This gallery shows some pictures of bad solderings - they should prevent you from making the same errors (feel free to add even more pictures here!)

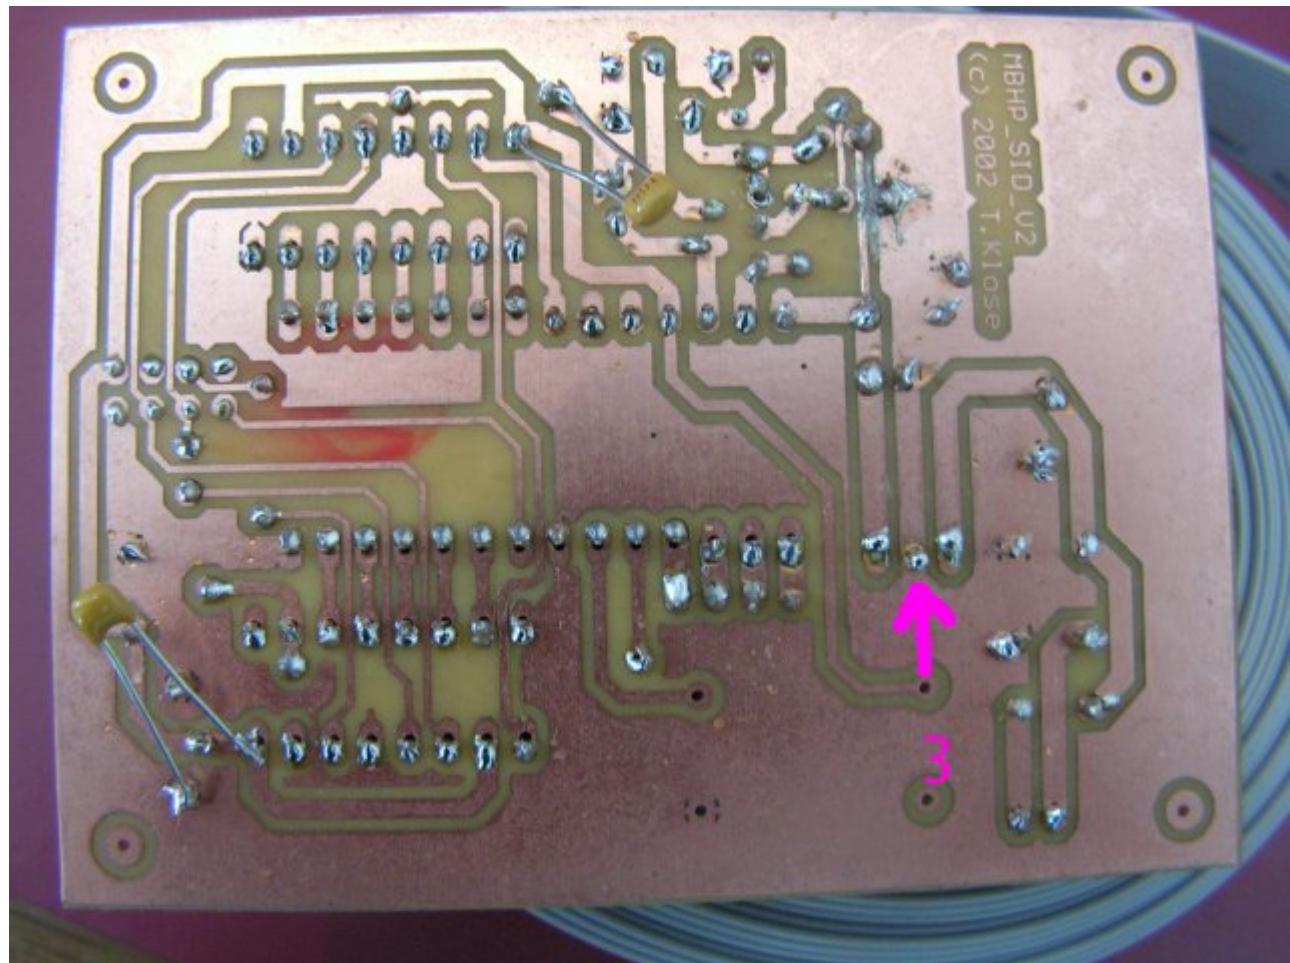
1: The core module has some badly soldered connections (loose), which could lead to failures. There are also missing solderings (e.g. 33pF cap below crystal). It makes sense to solder each pad again, the [Soldering](#) guide in the Wiki gives some useful tips

2: The legs of the caps should be cut, otherwise they can cause a short circuit which can damage the PIC!

3: This seems to be a bad ground connection directly at the 78xx - it can lead to the wrong voltage. Here the same: just solder the pads again, it will help

And same as above: the long cap legs need to be cut, the danger of shorting out is too high!
